## 11. POWER DISTRIBUTION COMPARISONS

In response to your letter of July 18, 1984, the NRC staff, with the technical assistance of Brookhaven National Laboratory (BNL), is reviewing Duke Power Company topical report DPC-NF-2010 which describes the nuclear physics methodology for reload design at the McGuire and Catawba Nuclear Stations. We find that additional information identified in the enclosure is needed to complete this review.

Subject: McGuire Nuclear Station - Docket No. 50-369/370  
Catawba Nuclear Station - Docket No. 50-413/414  
Response Request for Additional Information Regarding  
Topical Report DPC-NF-2010, "Nuclear Physics Metodology  
for Reload Design"

Subject: McGuire Nuclear Station - Docket No. 50-369/370  
Catawba Nuclear Station - Docket No. 50-413/414  
Response Request for Additional Information Regarding  
Topical Report DPC-NF-2010, "Nuclear Physics Metodology  
for Reload Design"

Figure 1. Burnable Poison Rod Configuration

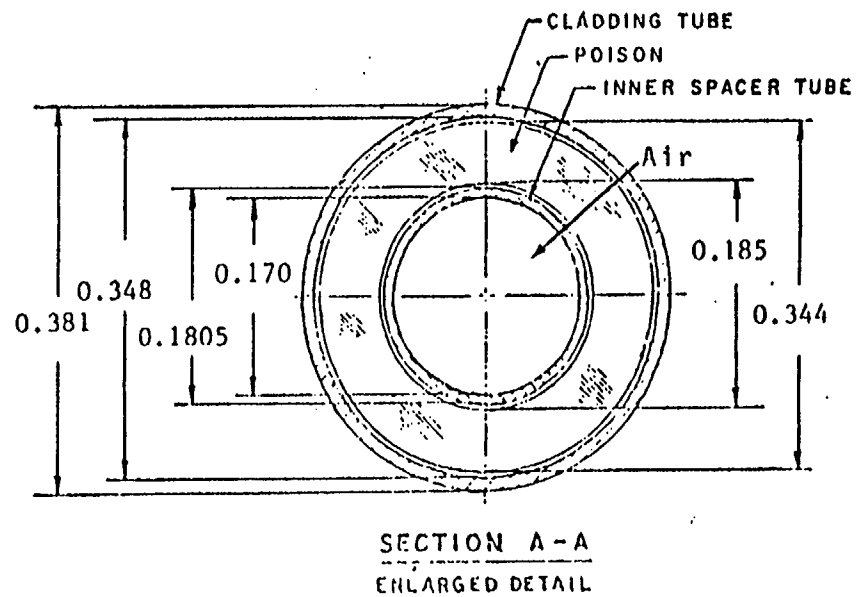
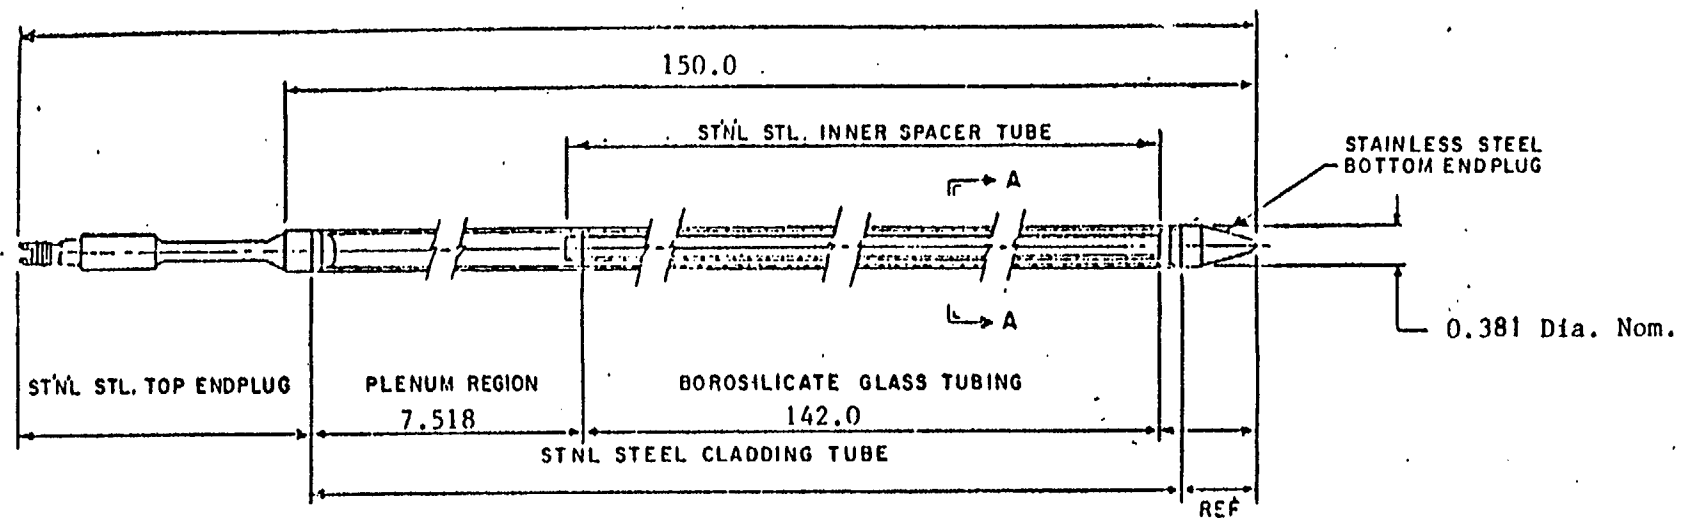
The standard problem is to be calculated in two dimensions in an iterated-source mode using reflecting boundary conditions in the horizontal plane neglecting axial leakage. The following series of assembly depletion and reactivity defect calculations are to be calculated.

Provide the following edited quantities for an assembly with and without burnable poison rods at BOL, 500, 5000, 10000, 20000, 30000 and 40000 Mwd/MT\*:
